8565EC-04

S E R V I C E N O T E

856xEC Series Portable Spectrum Analyzer

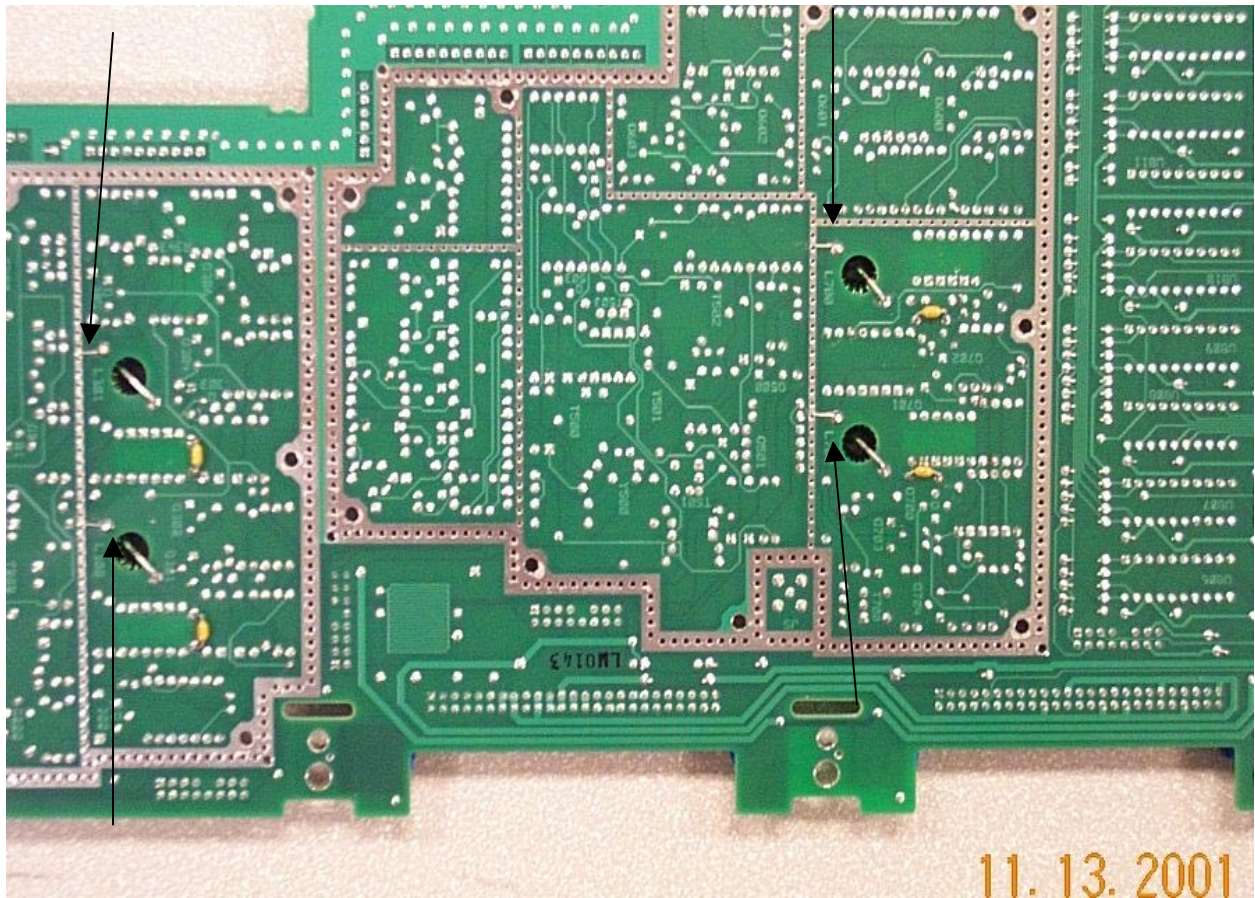
For the instruments specified above, inductors within the A5 IF assembly are not making good connections to ground thereby giving error messages related to the A4 Log Amp board. Error numbers that appear in the lower right-hand corner of the screen on account of this problem are errors 561, 562, and 565.

If the serial number of the instrument applies to the ones above, the following butch may solve the problem. Remove the shielding from the A5 IF assembly. Locate the inductors, and according to the attached photograph, insert and solder one end of the 8150-4222 wire into the hole connecting to the inductors and solder the other end to the ground plane on the front layer of the board. Do this for each inductor. See attached picture, the arrows point to where the jumpers are attached.

Add jumpers according to the picture above.
